PLANNING APPROVAL,
PLANNED UNIT DEVELOPMENT &
SUBDIVISION STAFF REPORT

Date: MAY 18, 2006

<u>NAME</u>	St. Luke Baptist Church
<u>LOCATION</u>	751 Texas Street (Southeast corner of Texas Street and South Bayou Street)
<u>CITY COUNCIL DISTRICT</u>	District 2
<u>PRESENT ZONING</u>	R-3, Multi-Family Residential
<u>AREA OF PROPERTY</u>	1.2 acres \pm
<u>CONTEMPLATED USE</u>	Planning Approval to allow the expansion of an existing church in an R-3, Multi-Family Residential District to include new restroom facilities and a fellowship hall, Planned Unit Development Approval to allow multiple buildings on a single building site, and creation of a 1 lot Subdivision.
<u>TIME SCHEDULE FOR DEVELOPMENT</u>	Immediate
<u>ENGINEERING COMMENTS</u>	Stormwater detention will be required for all impervious surfaces added since implementation of the COM Stormwater Ordinance (1983). The minimum finished floor elevation and the delineation between FEMA Flood zones x-shaded and AE will be required on the lot prior to final approval. Must comply with all stormwater and flood control ordinances. Any work performed in the right of way will require a right of way permit. The applicant is responsible for verify

SITE PLAN

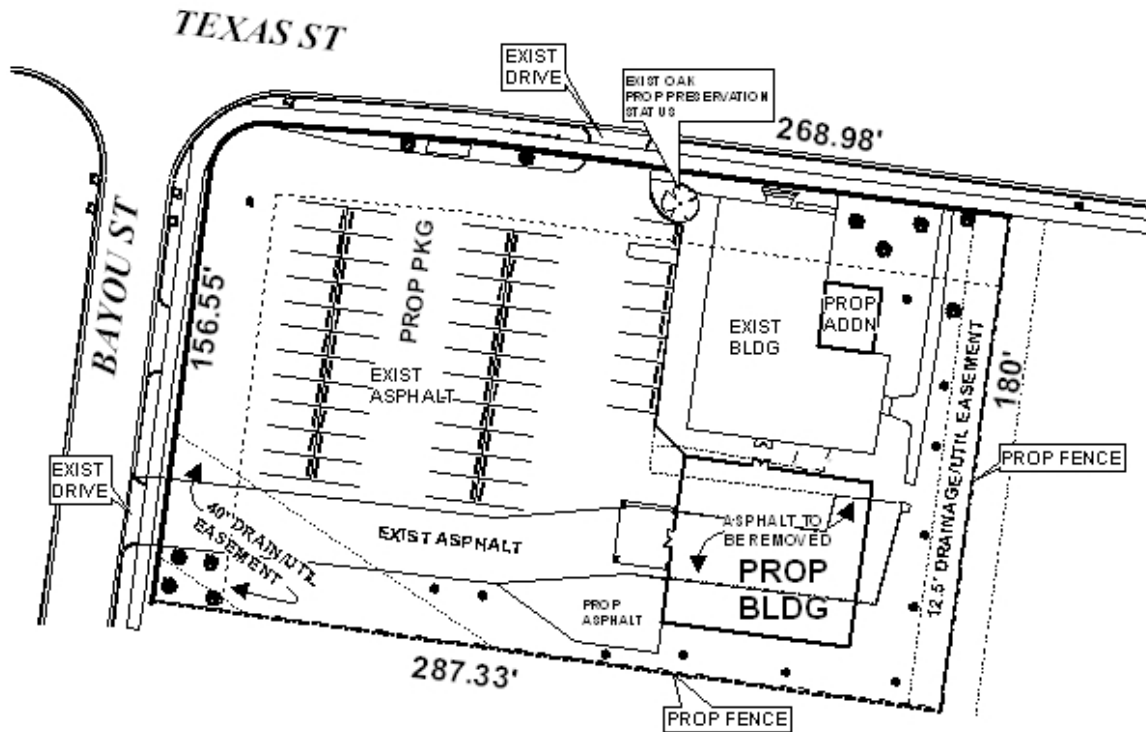
Landscape areas depicted on the site plan, where they are adjacent to the parking area, and the sidewalk must be protected from vehicular traffic in the parking area. Provision of a concrete curb where new asphalt is provided or concrete wheel stops (with rebar anchors) adjacent to proposed trees, existing protected trees, and the sidewalk should be provided. A sidewalk must be provided from the handicap parking area to the nearest handicap accessible entrance, therefore the site plan should be revised to depict the sidewalk.

Because the site abuts residential uses to the East and South, a protection buffer in conformance with Section 64-4.D. is required. The required protection buffer may be a 10-foot wide planting strip or a six (6) feet high privacy fence (except for the portion of the fence within the 25-foot setback line, which can only be 3-feet tall). The site plan should be revised to depict the required protection buffer.

Per the Engineering Department comments, on-site stormwater detention may be required. The site plan must be revised to depict any required stormwater detention facilities. A portion of the site appears to be located in the 100-year floodzone as indicated on FEMA maps, thus the Engineering Department is requiring that the applicant revise the site plan and plat to delineate

A 40-foot wide drainage and utility easement extends across the Southwest corner of the site. No permanent structures such as buildings are allowed within drainage and utility easements, thus a note should be placed on the site plan and plat stating such.

Finally, there is no indication on the site plan as to the proposed location of any dumpster or other waste storage facility. If the applicant utilizes a dumpster, the location of the storage area for the dumpster must be indicated on the site plan, and the location and required screening must comply Section 64-4.D.9. of the Zoning Ordinance, as well as with all other applicable regulations.

The applicant submitted a revised site plan depicting the requested items, and including the following notes:

- 1. The site will have curbside trash pickup.*
- 2. The site is limited to the existing curb cuts only.*
- 3. No permanent structures may be built within drainage and utility easements.*
- 4. Any work performed under or near existing 45" diameter Live Oak to be coordinated with Urban Forestry representative David Daughenbaugh.*
- 5. All new parking lot lighting will be properly shielded from adjacent residential property.*
- 6. Storm water detention to be provided in accordance with City of Mobile ordinance. Exact location to be determined in final design.*

As revised, the site plan addresses the identified concerns regarding the proposed improvements.

Planning Approval: *The request is recommended for Approval, subject to the following conditions: 1) depiction of stormwater detention, if required by City Engineering; 2) revision of note # 4 to read: "Preservation status is given to the 45-inch Live Oak Tree located on the Northwest side of the existing church building; any work on or under this tree is to be permitted and coordinated with Urban Forestry; removal to be permitted only in the case of disease or impending danger," and retaining of notes # 1-3, and 5-6, as depicted on the revised site plan; 3) completion of the Subdivision process; 4) full compliance with all other municipal codes and ordinances; and 5) provision of the revised site plan (depicting stormwater detention – if required – and revised note #4) to Urban Development.*

Planned Unit Development: *The request is recommended for Approval, subject to the following conditions: 1) depiction of stormwater detention, if required by City Engineering; 2) revision of note # 4 to read: "Preservation status is given to the 45-inch Live Oak Tree located on the Northwest side of the existing church building; any work on or under this tree is to be permitted and coordinated with Urban Forestry; removal to be permitted only in the case of disease or impending danger," and retaining of notes # 1-3, and 5-6, as depicted on the revised site plan; 3) completion of the Subdivision process; 4) full*

Subdivision: *The Subdivision request is recommended for Tentative Approval, subject to the following conditions: 1) placement of a note on the plat stating that the site is limited to the existing curb-cuts; 2) delineation of flood zones on the plat, per Engineering requirements; 3) notation of required finished floor elevations on the plat, per Engineering requirements; 4) placement of a note on the plat stating that no permanent structures may be built within the drainage and utility easements; and 5) full compliance with all other municipal codes and ordinances.*
